City of El Paso – City Plan Commission Staff Report

Case No:	SUSU12-00050 Haciendas Del Rio
Application Type:	Major Combination
CPC Hearing Date:	October 4, 2012
Staff Planner:	Nathaniel Baker, (915) 541-4192, bakernt@elpasotexas.gov
Location:	West of Doniphan Drive and South of La Union Avenue
Acreage:	91.8 acres
Rep District:	West ETJ
Existing Use:	Farmland
Existing Zoning:	ETJ
Proposed Zoning:	ETJ
Nearest Park:	Rio Grande River Trail (Adjacent)
Nearest School:	Jose Damiam Elementary (1.4 miles)
Park Fees Required:	N/A
Impact Fee Area:	Westside Impact Fee Area
Property Owner:	Haciendas Del Rio Partners LP
Applicant:	Haciendas Del Rio Partners LP
Representative:	CAD Consulting Company

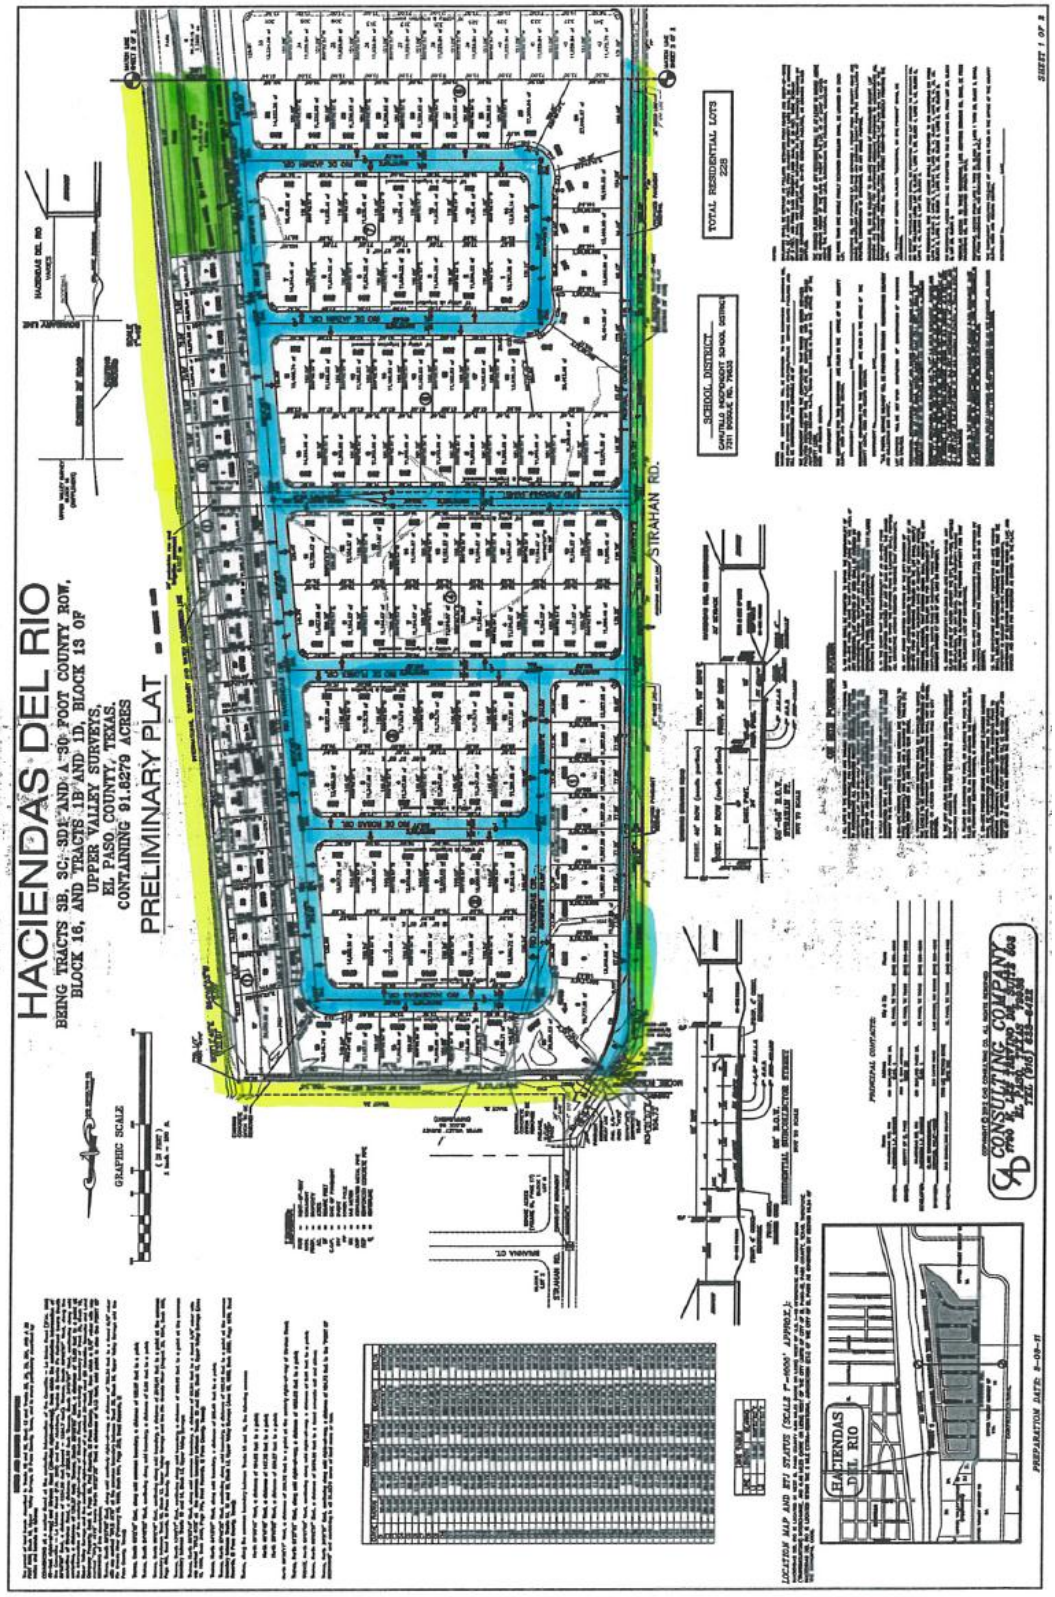
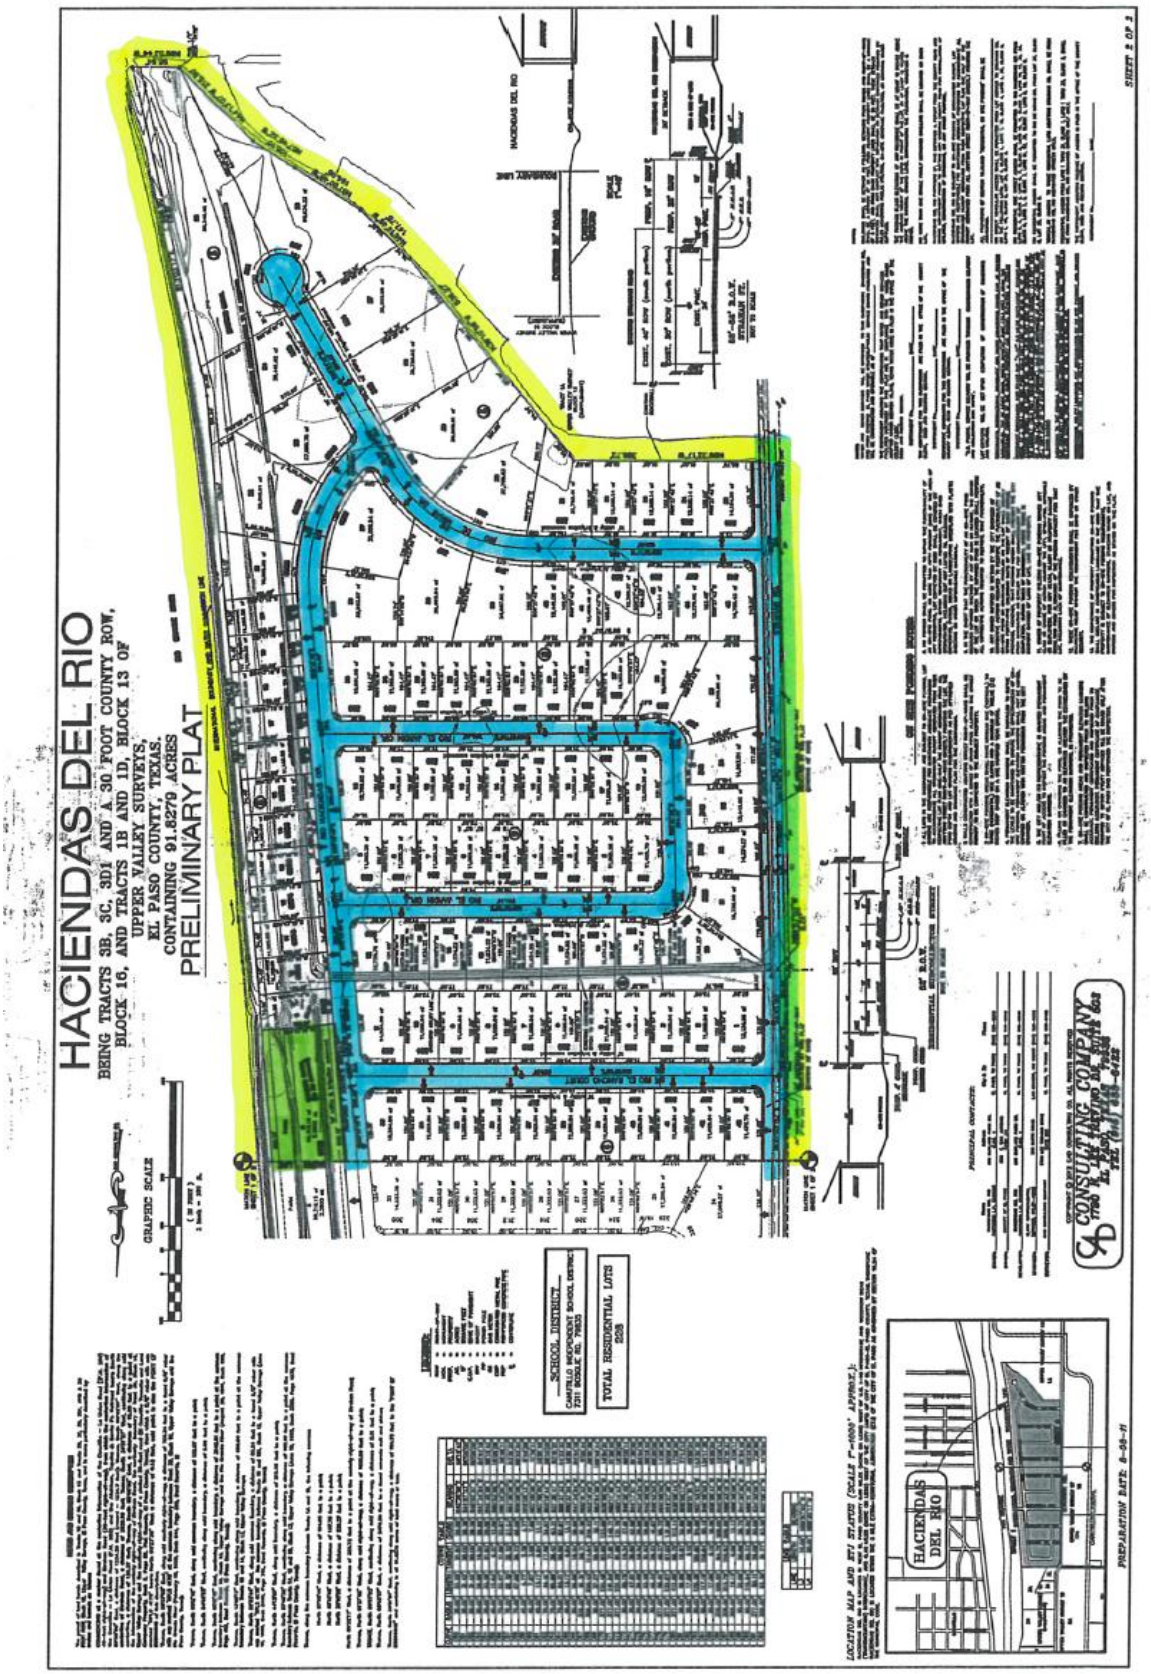
1. Vehicular access to Lot 37 Block 8 and Lot 23 Block 5 shall be from Rio Haciendas not Rio de Minas.
2. Add the following note: No structures exceeding 36 in. in height shall be located within the visibility easement located at Lot 37, Block 8
3. Developer shall provide traffic calming devices on Rio Haciendas Circle in accordance with the Amendment to the Development Agreement dated march 10, 2009; such traffic control shall be coordinated with El Paso Department of Transportation and reflected on the improvement plans for the subdivision.

The Haciendas Del Rio Plat presented for this review increases the number of lots compared to the plat originally presented to EPWU-PSB by the Developer.

EPWU-PSB respectfully requests the Developer to submit the updates to Haciendas Del Rio to enable this office to update the water and sanitary sewer plans and Record information as per the new plat configuration.

1. The plat indicates on-site ponding will be used to manage stormwater runoff. To establish the feasibility of the proposed residential on-site ponding, the applicant shall submit hydraulic calculations prepared by a Professional Engineer as per Section 19.16.060C of the previous subdivision ordinance (March 11, 1997 – June 1, 2008). The submittal shall conform to the requirements outlined in Section J of the Drainage Plan Standard Detail of the City's Design Standards for Construction and the requirements outlined in Section 19.16.060C (1-7) of the previous subdivision ordinance. If on-site ponding as proposed is determined to be unfeasible, ponding in a common retention pond shall be required.

2. Provide the following on-site ponding requirements which reference the ***County*** of El Paso on the Preliminary Plat and the Final Plat sheets.
